ADDENDUM NO. 5

October 3, 2025

VALE FACILITY ADDITION/RENOVATIONS AND MAINTENANCE/IT FACILITY PROJECTS

Addendum Five (AD.05) to the drawings and specifications prepared by Gibraltar Design for **Valparaiso Vale Facility Addition/Renovations and Maintenance/It Facility and Related Work** for Valparaiso Community Schools, Valparaiso, Indiana.

DRAWING
PLUMBING RISER DIAGRAMS

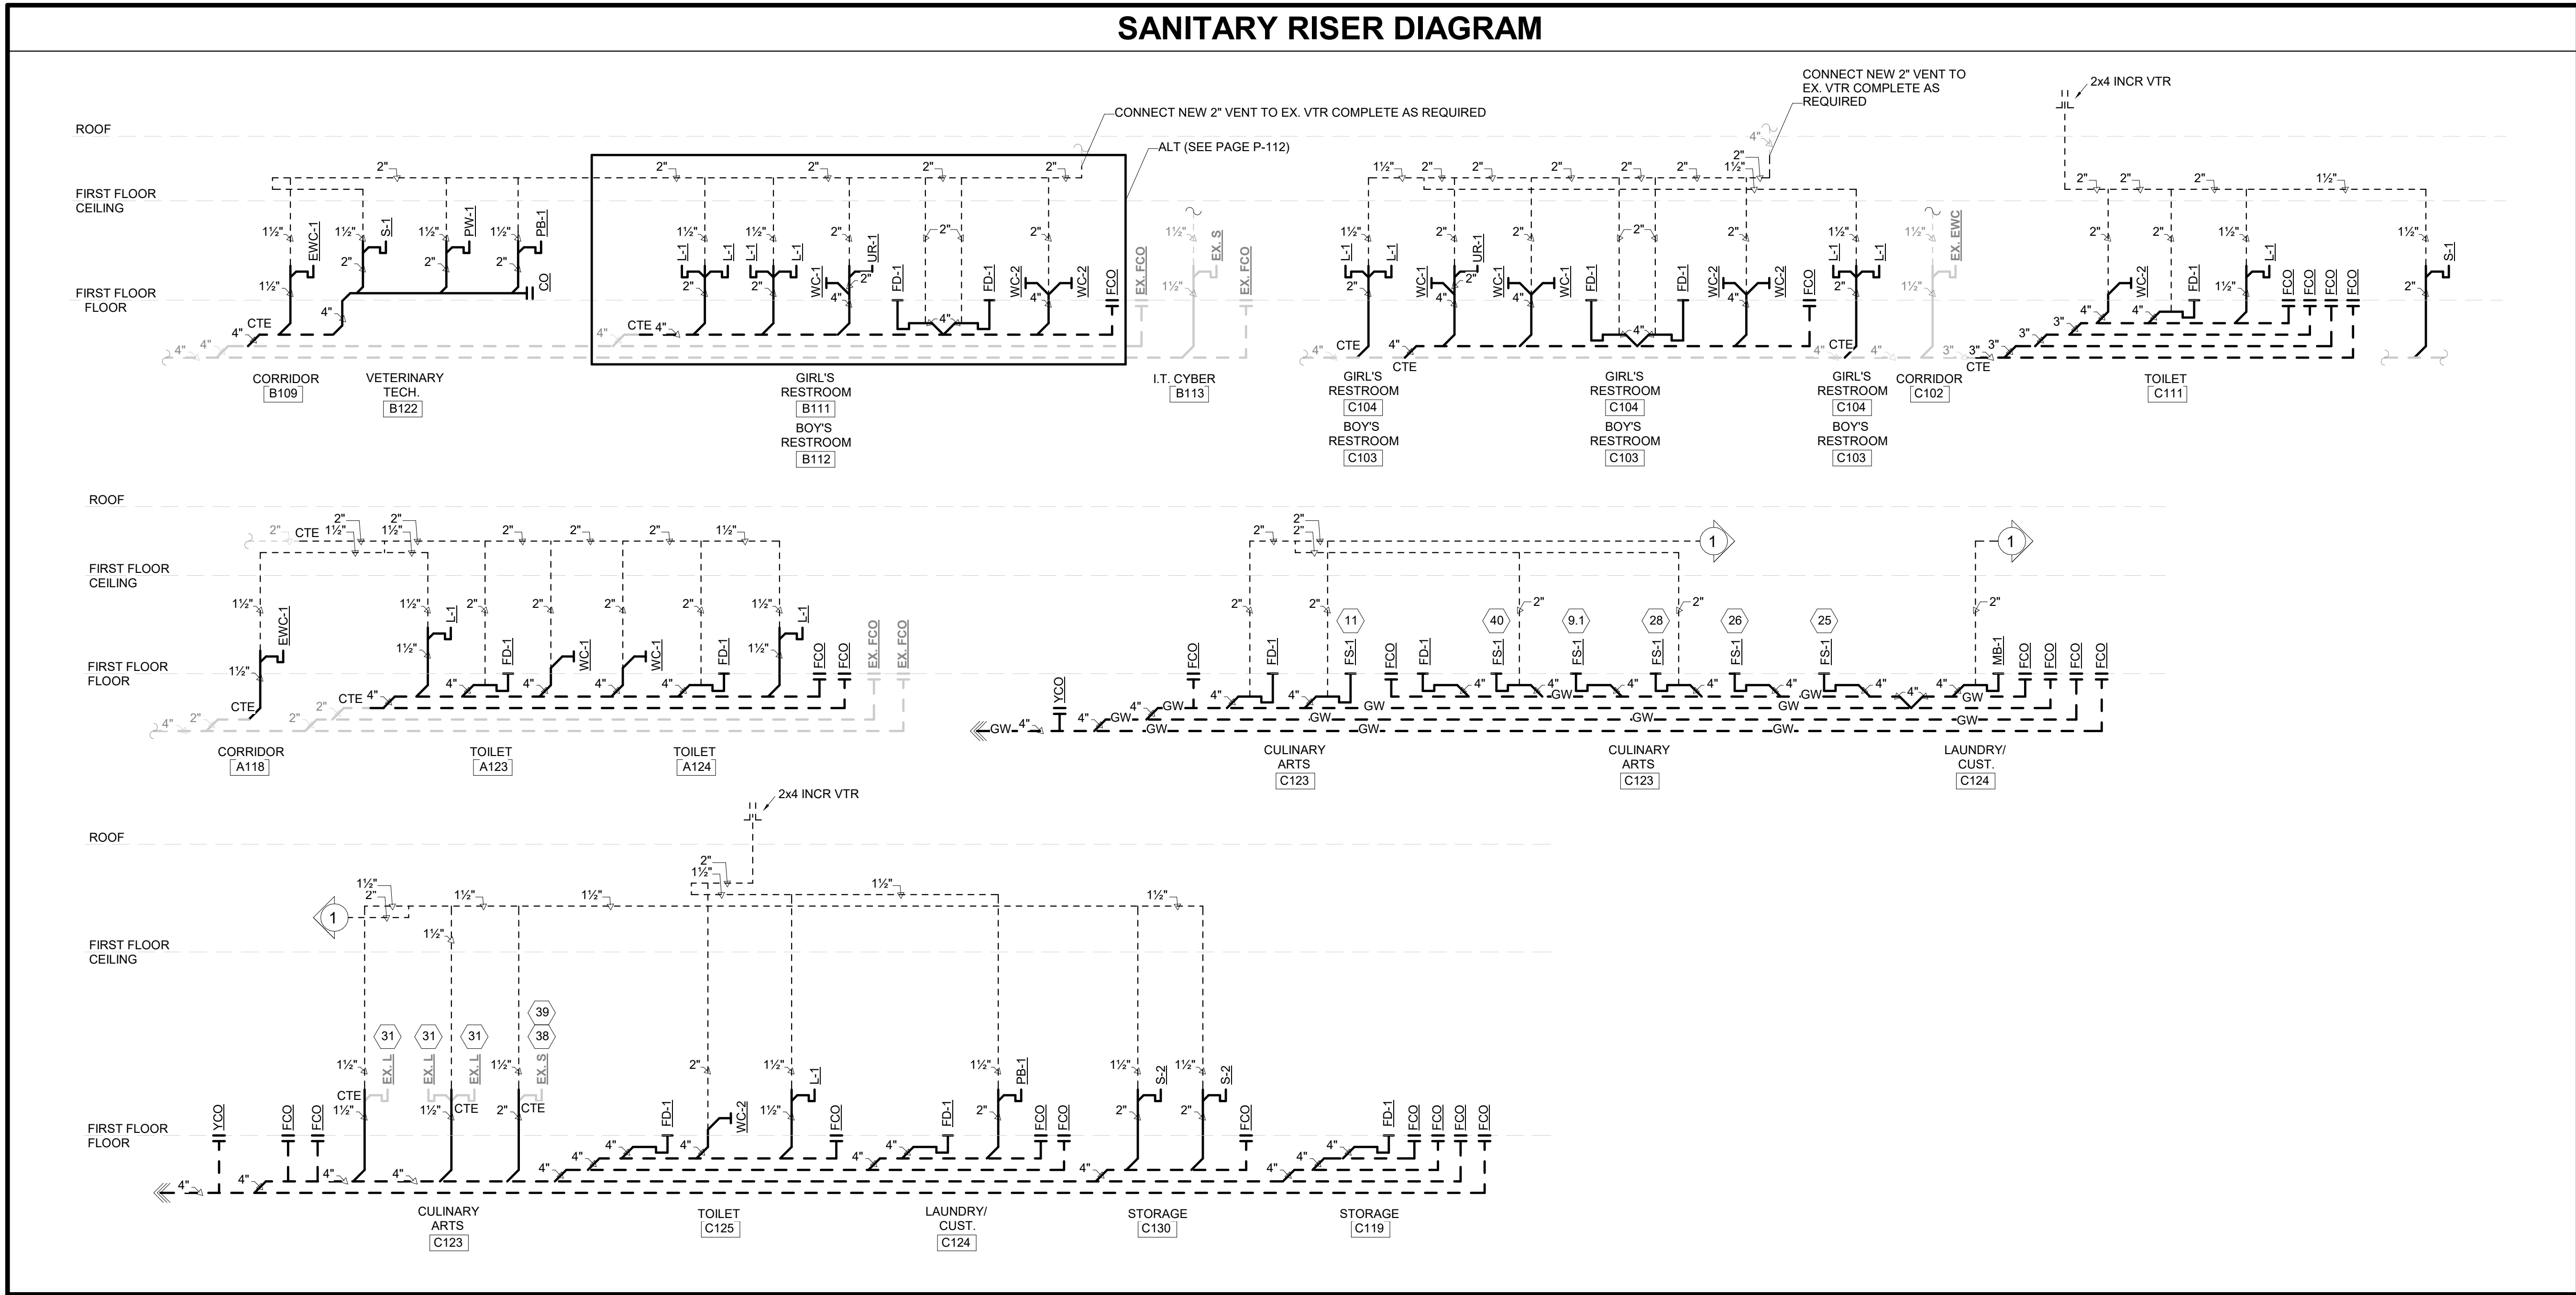
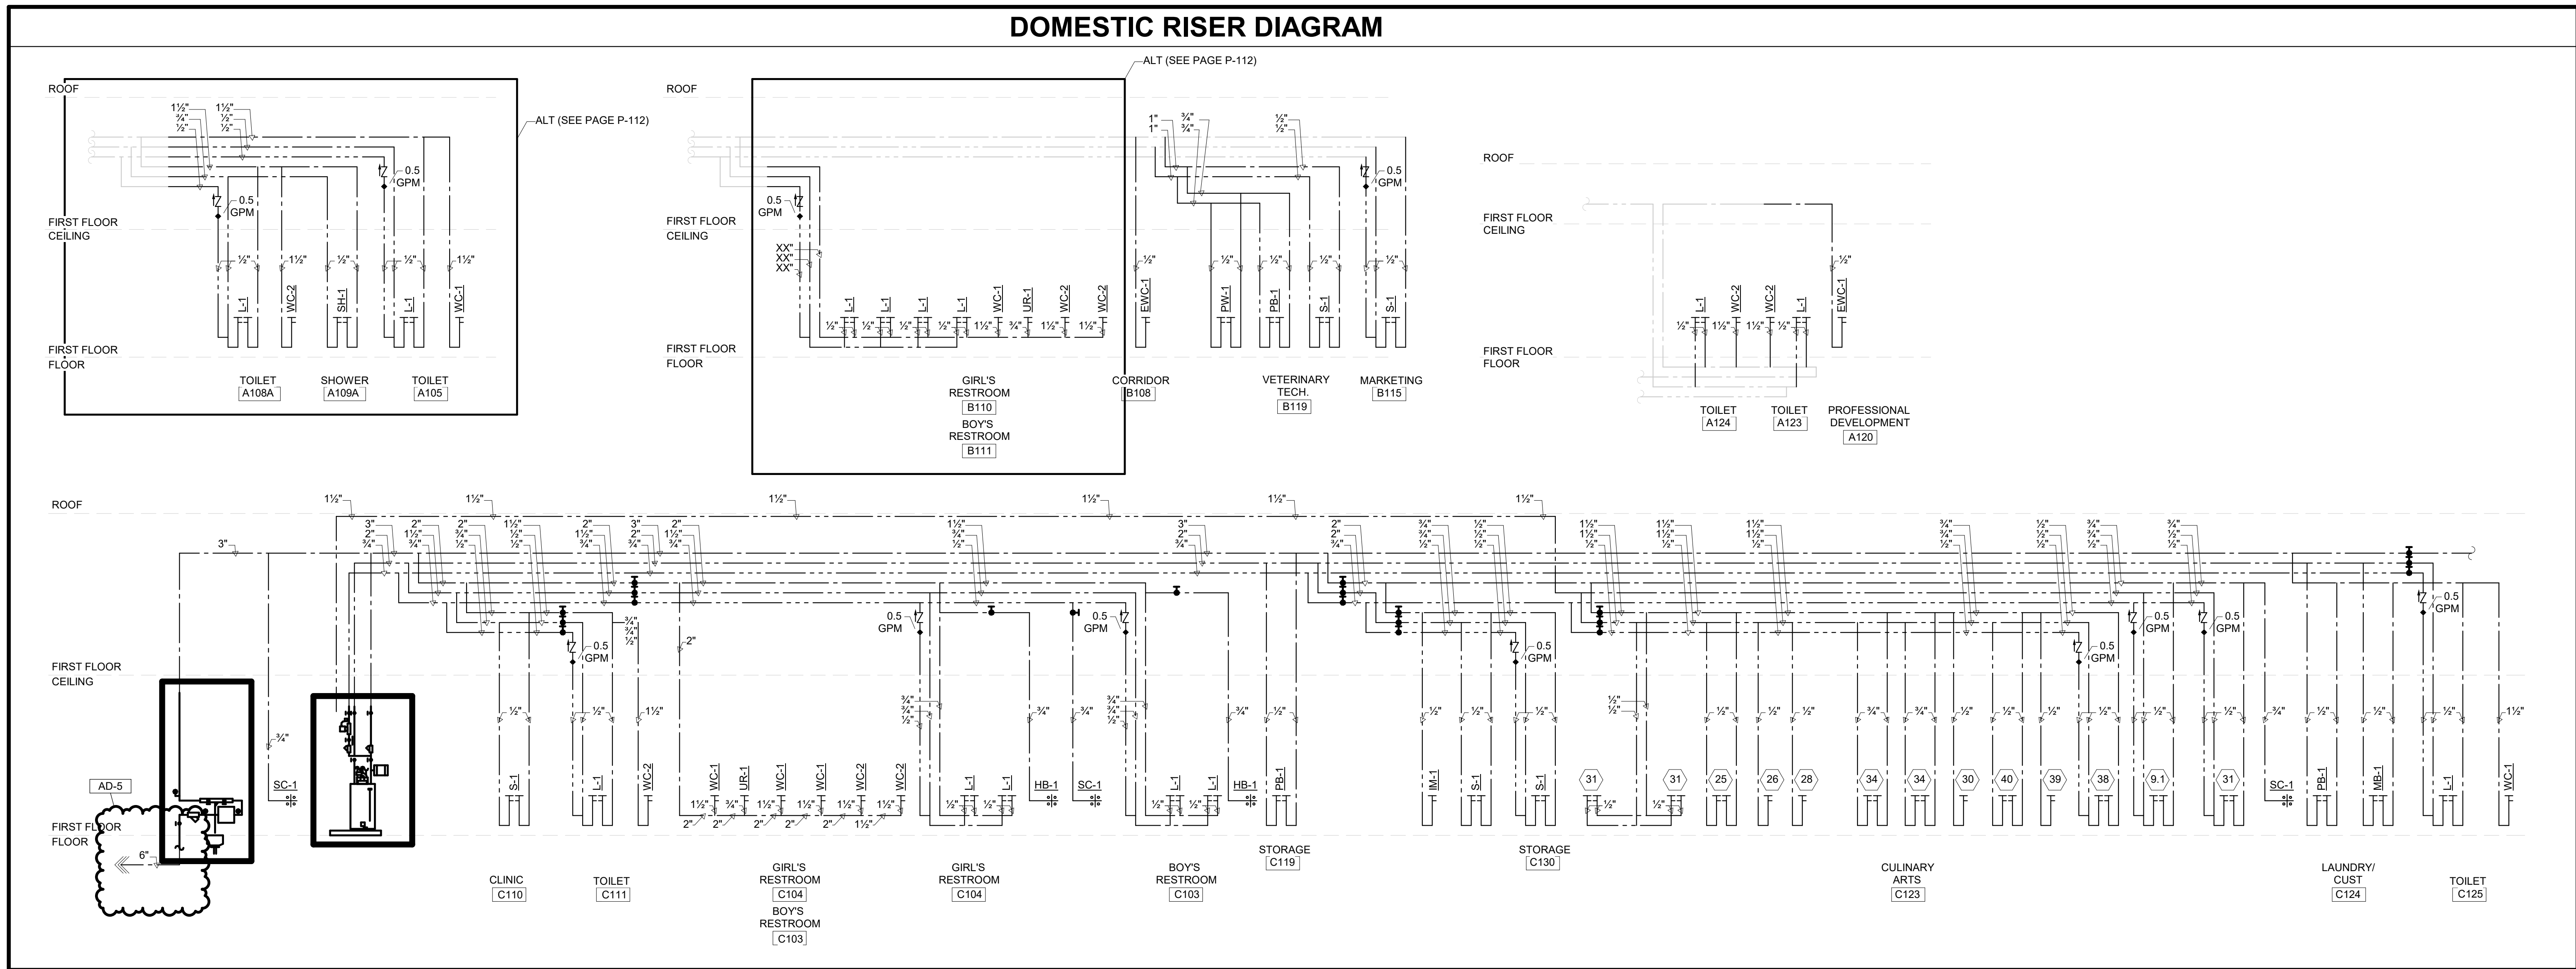
17. Sheet P-501

- A. Revised the Incoming Domestic Water Service Diagram to show 6" domestic water line into the building and transitioning to a 3" water service.

18. Sheet P-502

- A. Revised the Domestic Water Riser Diagram to show 6" domestic water line into the building and transitioning to a 3" water service.
